CITY OF VANCOUVER
POLICY REPORT
DEVELOPMENT AND BUILDING

Report Date: February 21, 2007
Author: A. Riley
Phone No.: 604.871.6269
RTS No.: 06446
VanRIMS No.: 11-3600-10
Meeting Date: March 13, 2007

TO: Vancouver City Council
FROM: Director of Planning
SUBJECT: CD-1 Rezoning - 5909-5989 Oak Street

SH STUART HOWARD ARCHITECTS INC.
 5090 - 5092 OAK STREET VANCOUVER BC
 Project No: **MONTGOMERY ESTATES**
 Sheet No: **1/16" SITE PLAN**

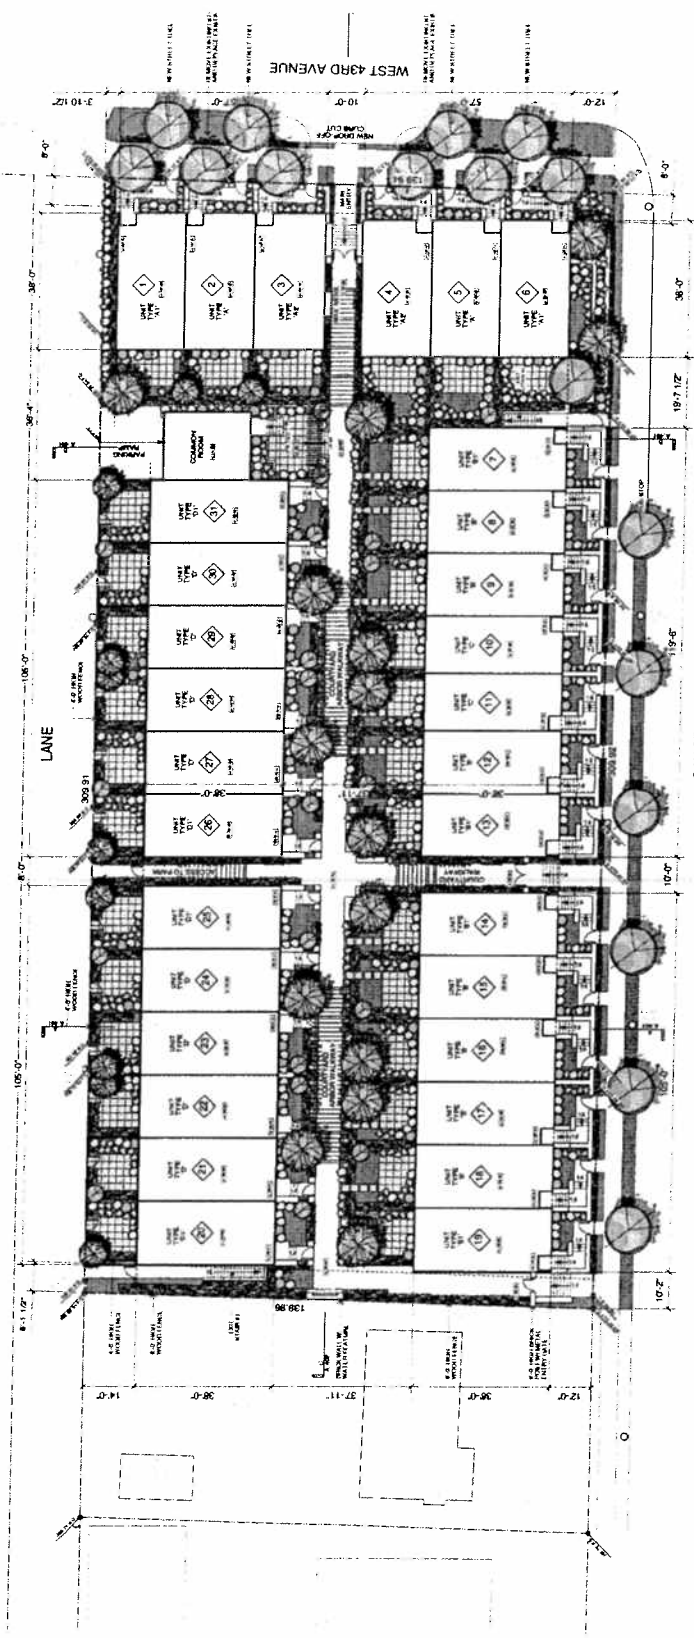
- (ii) Design development to improve the public realm interface along Oak Street, providing a second inner row of trees inside the property line.

Note to Applicant: A second row of trees is to be located inside the property line, providing a three foot clear width. Consider realigning entry stairs perpendicular to the main entry doors to achieve sufficient spacing for trees.

- (iii) Design development to the lane edge conditions, providing a layered landscape border and improving the orientation and visual connections of the rear facing townhouses towards the lane and the park.

Note to Applicant: Provide at the lane edge a three foot landscape setback with a raised curb edge, a continuous row of trees and low level pedestrian lighting. Fences should be located inside, to the east of the landscaped setback, with gated entries and specialty paving. The width of the inner courtyard may be reduced slightly to achieve these objectives.

- (vi) Design development to the landscape courtyard, creating areas of special interest and focus, providing more variety and opportunities for social interaction.

Note to Applicant: The trellis element should be broken up into smaller, less continuous sections, allowing for more openness and views to the sky. Provide areas of special focus with bench seating and a water feature.

1. The northwest units (#20-25) do not appear to meet the intent of subsection 3.2.5.5 of the VBBL in that the travel distance to the principal entrance of these units exceeds 45 m.
2. The CACF for this site is to be located within 100 m of a City Fire Hydrant per new VBBL.
3. The VFERS do not consider a City lane as an acceptable access route, therefore access to units #20-31 via the lane is not acceptable per A-3.2.5.6. (1) VBBL.
4. The access routes must meet the intent as defined in A-3.2.5.5. (1) VBBL.

5. There must be a City hydrant located within 100 m of each principal entrance of this site. There is no indication of a City hydrant on the submitted plans. If a City hydrant cannot be provided, there must be a private hydrant so that service to the site is acceptable.
6. The units off of Oak Street must meet the requirements of A-3.2.5.5. (3) VBBL.
